PIC16C62

PIC16C62 Rev. A Silicon Errata Sheet

The PIC16C62 (Rev. A) parts you have received conform functionally to the Device Data Sheet (DS30234D), except for the anomalies described below.

FIGURE 1: WRITES TO TIMER1 (EXTERNAL CLOCK / OSCILLATOR MODE)

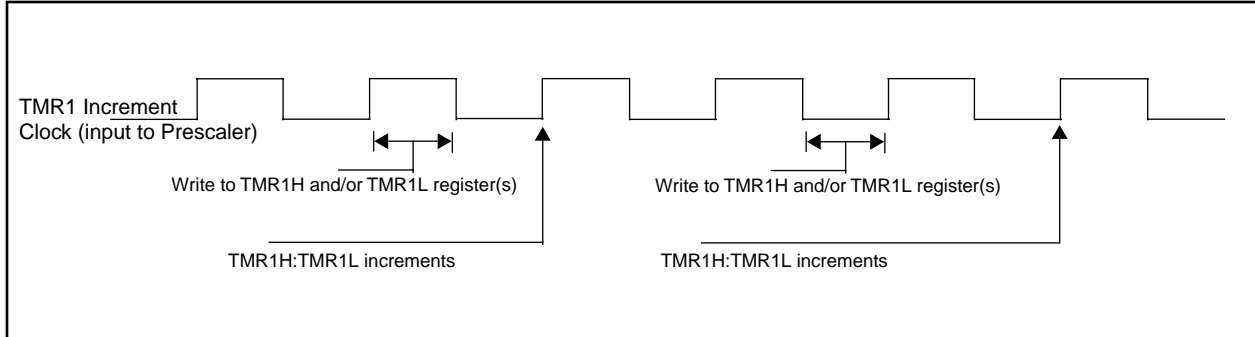
- a) The operation of Timer1 needs some clarification when the timer registers are written when the TMR1ON bit is set.

The internal clock signal that is the input to the TMR1 prescaler affects the incrementing of Timer1 (TMR1H:TMR1L registers and the Timer1 prescaler). When the Timer1 registers are NOT written, the Timer1 will increment on the rising edge of the TMR1 increment clock.

When the TMR1H and/or TMR1L registers are written while this clock is high, TMR1 will increment on the next rising edge of this clock.

When the TMR1H and/or TMR1L registers are written while this clock is low, TMR1 will not increment on the next rising edge of this clock, but must first have a falling clock and then the rising clock for TMR1 to increment.

Figure 1 shows the two cases of writes to the TMR1H and/or TMR1L registers. Due to the V_{IH} and V_{IL} thresholds on the oscillator/clock pins, external

Timer1 oscillator components, and external clock frequency, the Timer1 increment clock may not be of a 50% duty cycle.

The TMR1 increment clock is out of phase of the T1OSO/T1CKI pin by a small propagation delay.
